May 24, 2021

RE: Draft Resolution E-5150. Adopts updates to the Avoided Cost Calculator for use in demand-side distributed energy resource cost-effectiveness analyses

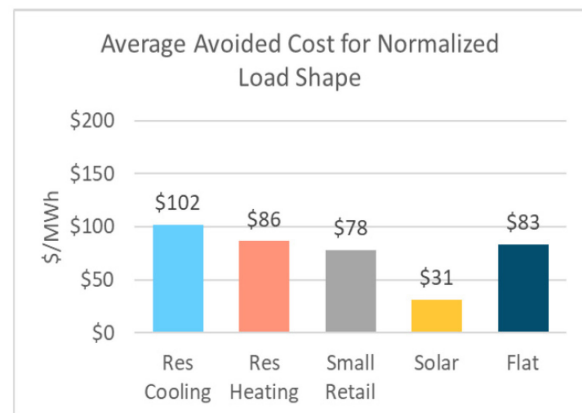
California, including the value of distributed solar and energy efficiency measures. Reproduced below is Figure 4 from the Documentation file for the draft 2021 ACC, showing the single-year change in the value of selected DERs in 2030. The value of solar PV drops by 74%, from 11.7 cents per kWh to 3.1 cents per kWh. Using the detailed hourly outputs in the draft 2021 ACC, we have calculated that similar declines would occur in the value of solar over longer time horizons; for example, the 25-year levelized value of solar from 2021-2045 would drop by 60% to 66%. The value of energy efficiency measures also would drop substantially, on the order of a 50% reduction. There is nothing that has occurred in the California energy market over the last year that justifies such a major drop in the value of distributed resources. In the past, the Solar Parties have supported the Commission’s effort to integrate the valuation of demand- and supply-side resources by using key values from the IRP in the ACC. However, this effort will not succeed if the result is that the values of DERs fluctuate wildly from year-to-year based on modeling and methodology changes over which the Commission fails to exercise adequate oversight. To prevent this, the IRP values used in the ACC must reflect the most recent Commission-approved resource plan that has been thoroughly vetted in the IRP proceeding, not unvetted values from whatever is the latest model run by Commission staff or its consultants. Changes in resource scenarios and modeling methods should occur only in conjunction with fully-litigated “major” updates to the ACC.

Accordingly, and for reasons detailed herein, the Solar Parties recommend that the Commission reject the three “major” changes discussed in Section II below. Specifically, the Commission should continue to use in the 2021 ACC the same components that were derived from the approved RSP in the IRP proceeding, including the greenhouse gas (“GHG”) shadow prices used in the ACC’s GHG Adder and the marginal heat rates based on the SERVVM production cost modeling of the adopted RSP portfolio, using the scarcity pricing and benchmarking methods approved in D. 20-04-010 and Resolution E-5077.

Figure 1

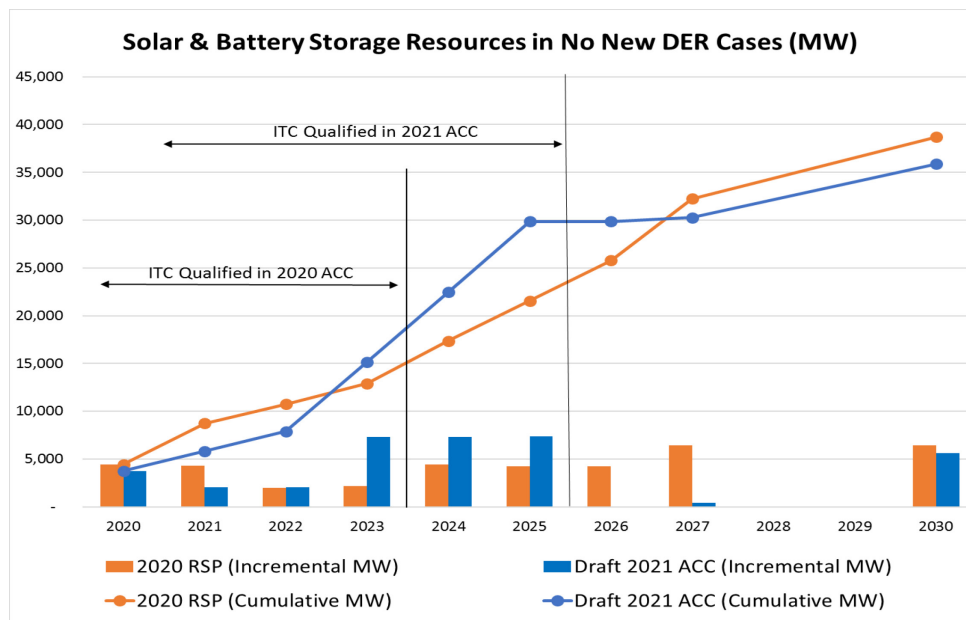
Figure 1 below compares the solar and storage build-outs in the 2020 and draft 2021 ACCs, showing that the draft 2021 ACC assumes that almost 85% of the solar and storage needed in 2030 – a full 30 GW – is installed in the next four years, by 2025, compared to 33% in the 2020 ACC.¹⁰ This 30 GW includes 18 GW of solar and 12 GW of storage. This change in the timing of solar and storage additions accounts for much of the reduction in the 2030 GHG Adder in the draft 2021 ACC.

The Solar Parties want to see a continued expansion of utility-scale solar in the state, but it is not realistic to assume that 18 GW of new utility-scale solar – 150% more than the state’s entire existing utility-scale solar fleet – and 12 GW of new storage – perhaps ten times the existing battery storage capacity – could be built in California in the next four years.

Figure 1 Price Duration - CAISO 2019 vs. SERVVM 2020 and SERVVM 2030

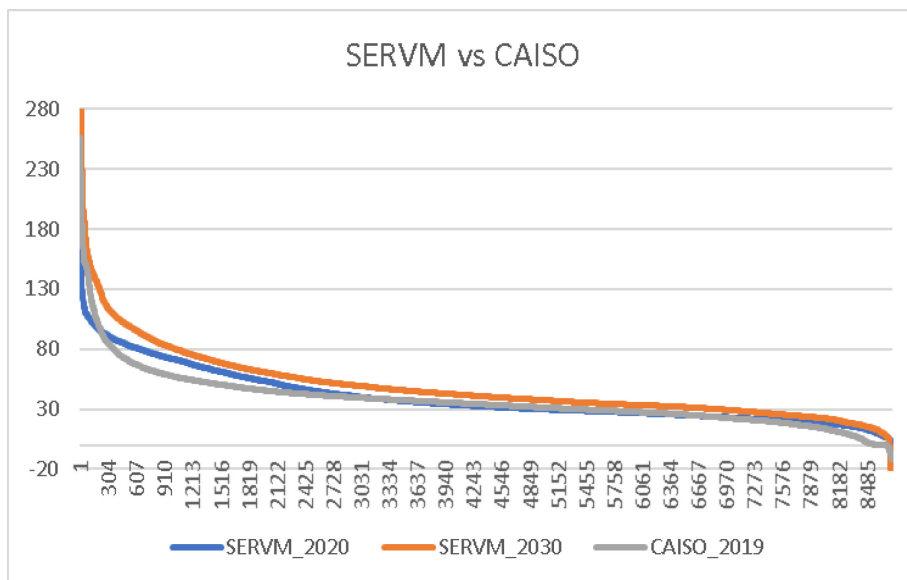
The “Additional SERVVM information” posted May 19 includes a figure with price duration curves that purports to compare 2020 and 2030 SERVVM prices to 2019 CAISO prices, as an example of the staff’s benchmarking effort. Here is that figure:

The problem with this figure is that the 2020 and 2030 SERVM prices shown are not the SERVM prices used in the draft 2021 ACC. **Figure 3** below shows the 2020 and 2030 SERVM prices actually used in the 2021 ACC.¹⁹

Figure 3

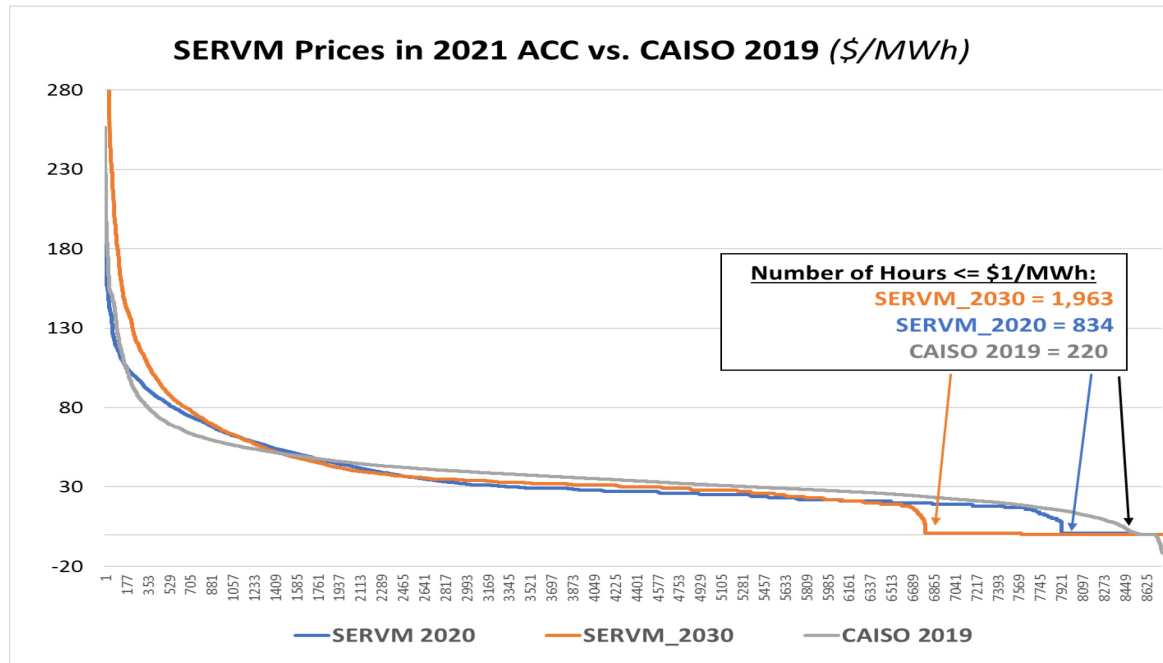
The obvious difference between the staff's figure and Figure 3 is that the SERVM prices used in the 2021 ACC have zero or near-zero prices in a significant fraction of hours (834 hours with prices of \$0 or \$1/MWh in the 2020 SERVM results, and 1,963 such hours in the 2030 SERVM prices), while 2019 CAISO market prices had 220 such hours. We asked staff a follow-up question about the discrepancy between these two figures in an email on May 19. Staff responded that the difference between the 2020 and 2030 SERVM prices in these two figures is that the SERVM prices in the staff's figure include GHG cap & trade ("C&T") costs, while the SERVM prices used in the 2021 ACC do not.²⁰ But this cannot be true at the low end of the

curve – it would mean, for example, that in 2030 SERVM models 1,963 hours in which generators bid only C&T costs because the price is \$1 per MWh or zero or when C&T costs are removed. But this makes no sense – why would a fossil generator bid their C&T costs but not their fuel costs? Further, C&T costs cannot account for the difference in the SERVM prices between the staff’s figure and our Figure 3 at the low end of the price duration curve, because C&T costs in 2020 and 2030 are about \$6 and \$8 per MWh, which is much less than the \$15 to \$30 per MWh differences shown in most of these hours.²¹ By email on May 21 we asked staff to explain these zero-price hours, but have received no response to that inquiry. Thus, in 2030 the draft 2021 ACC includes 22% of the hours of the year with zero or near-zero prices, in a No New DER case in which loads are much higher due to the removal of DERs.²² Staff has not explained how this result makes sense or why it is realistic.

Figure 10. Impact of previous year's scarcity adjustment on raw SERVM prices relative to historical data

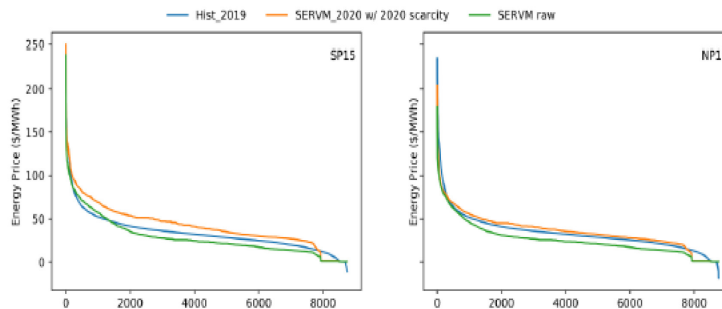
Figure 10 shows that the 2020 scarcity method accurately tracked 2019 prices in NP-15 across most hours; the 2020 method overestimated SP-15 prices.

Figure 11. Impact of current year's scarcity adjustment on raw SERVM prices relative to historical data

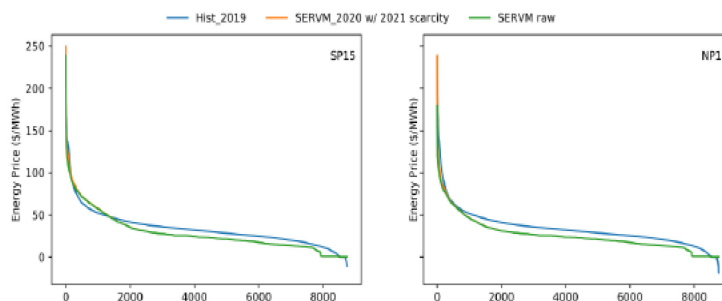
But Figure 11 shows that the new method, which only adjusts the highest prices, systematically underestimates both NP-15 and SP-15 prices, and the SERVM prices produce more hours with very low or zero prices than were actually experienced in 2019. For NP-15, the new approach is clearly less accurate than the 2020 method in the bulk of the hours when prices are moderate.

Thus, it is far from clear from these figures that the new scarcity method improves on the 2020 approach, in terms of accurately representing 2019 prices. What is obvious is that the new method produces significantly lower prices in almost all hours.
